MEMORANDUM

To: Bayonne Zoning Board of Adjustment  
From: Brian Slaugh, PP, AICP  
Isabel Rodriguez, AICP  
Re: **Lou Chiorazzi**  
**ZBA Application Z-24-010**  
Bulk Variances  
Block 449, Lot 12  
129 Avenue F  
Transit Development Overlay (TDO) District  
R-2 Detached/Attached Residential District  
Date: January 22, 2025

Image of Building Facade from Google Street View.

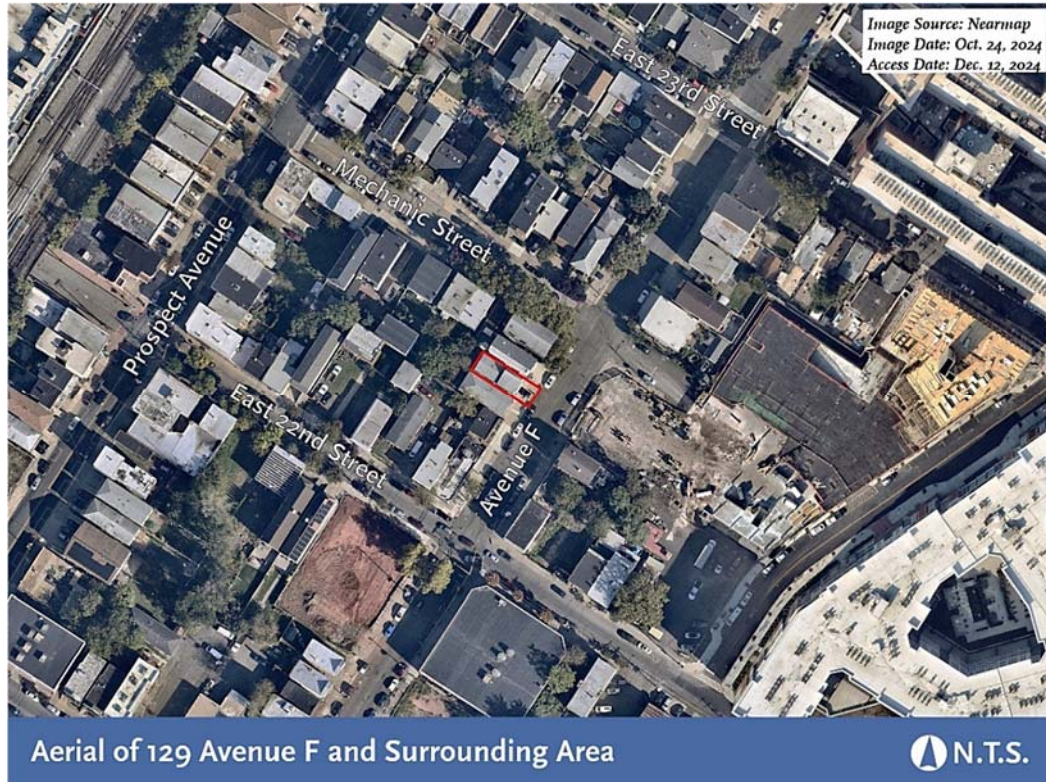
The architectural plan that accompanies the application indicates that the building has already

been converted into a two-family dwelling. In addition to the garage on the first floor, the first floor has a studio apartment behind the garage and staircase to the second floor. On the second floor, there is a living room above the garage, kitchen, three bedrooms and two baths. No physical changes appear to be proposed.
